Central Zoo Authority

F. No. 19-256/93-CZA(193)(Vol. IV)(M) | 4693 DATE: 21.04.2014

Sub:- Proposed designs for the construction of various enclosures at Nagaland Zoological Park, Rangapahar.

PLAN/ELEVATION : CHAINLINK FENCE : MACQUE

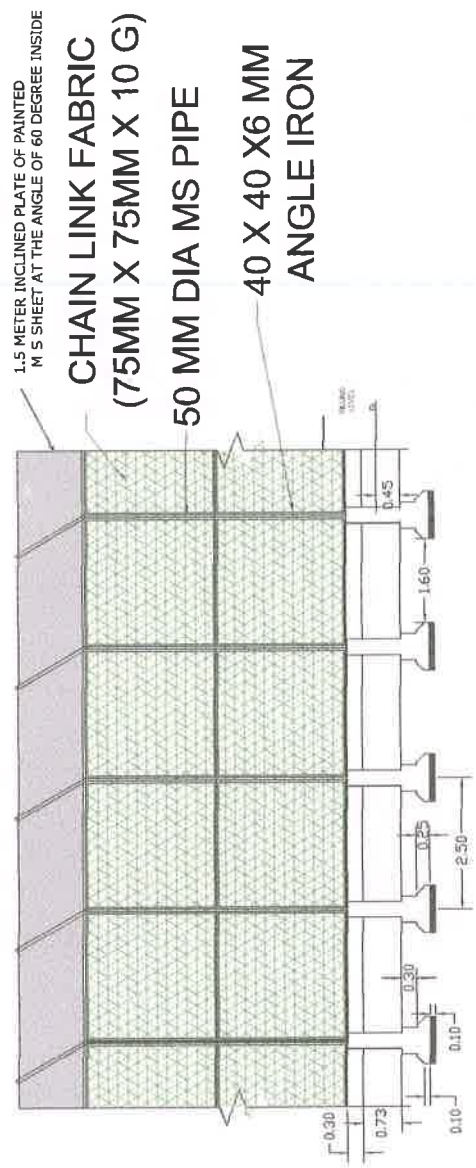
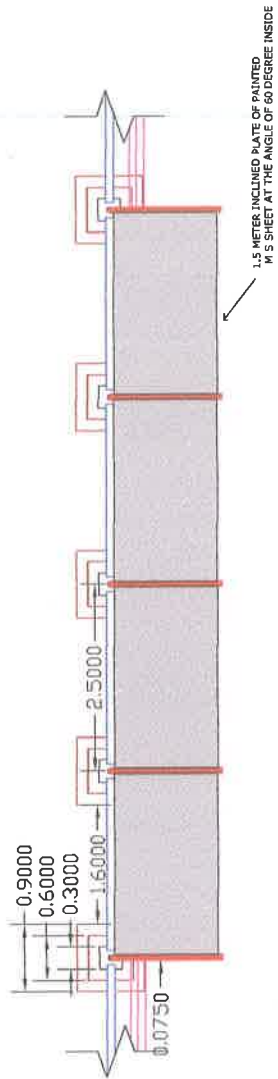
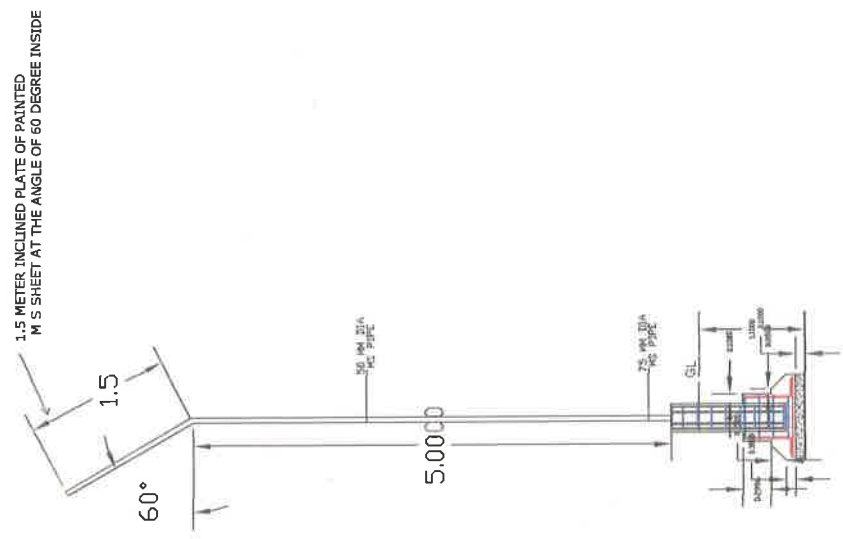
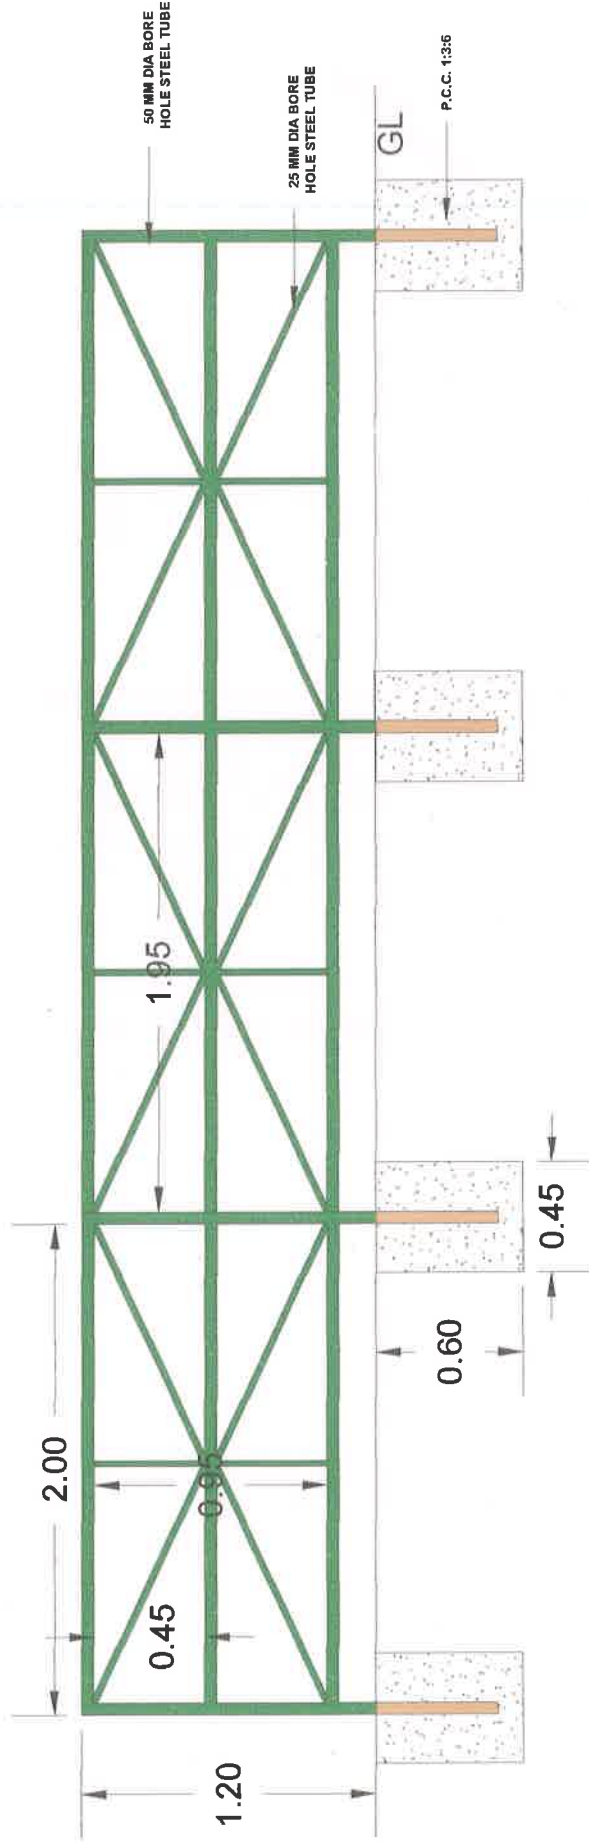
- a) The width of dry moat should not be more than 5 mts and the depth should not be more than 4 mts.
- b) The overhang of the chain link fence is not required. However stainless steel plate of 1.5 mt wide should be provided as overhang instead of mild steel/corrugated sheet.
